**FINAL PRODUCT/PROCESS CHANGE NOTIFICATION # 16665A**Generic Copy

**Issue Date:** 30-Jul-2012**TITLE:** Discontinuance of Part number 12095-801-XTD and conversion to 12095-804-XTD**PROPOSED FIRST SHIP DATE:** 30-Oct-2012**AFFECTED CHANGE CATEGORY(S):** Assembly – Plating Material**FOR ANY QUESTIONS CONCERNING THIS NOTIFICATION:**Contact your local ON Semiconductor Sales Office or Sarah Sanico <[ffxxxh@onsemi.com](mailto:ffxxxh@onsemi.com)>**NOTIFICATION TYPE:**

**Table 1:** SCANNING ACOUSTIC MISCROPY PHOTO

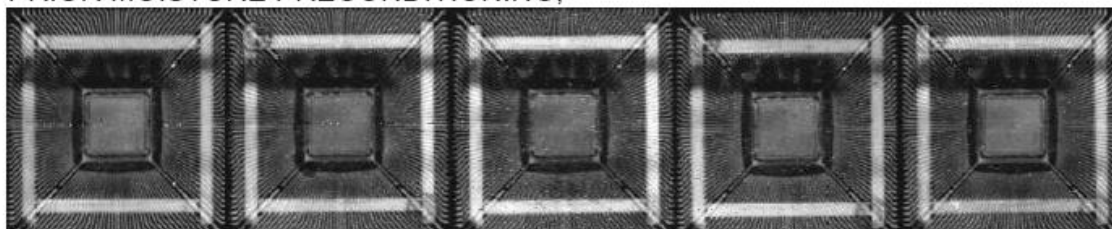
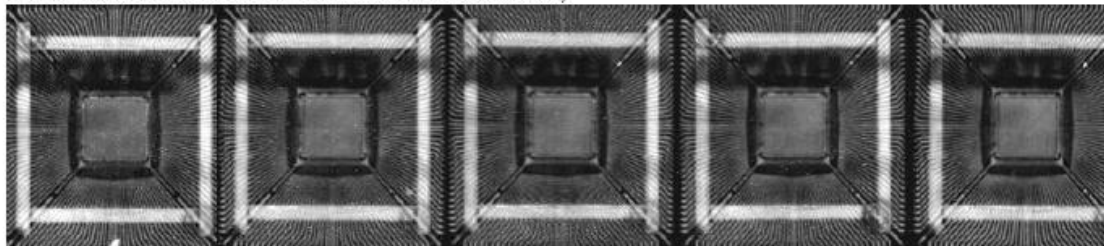
The assembly qualification tests have concluded with passing results. No failures were incurred on all tests. On Semiconductor released the package and green material set under consideration for dry pack level 3 of IPC/JEDEC standard J-STD-020 (Moisture/Reflow Sensitivity Classification for Non-Hermetic Solid State Surface Mount Devices).

PRIOR MOISTURE PRECONDITIONING,

AFTER MOISTURE PRECONDITIONING,
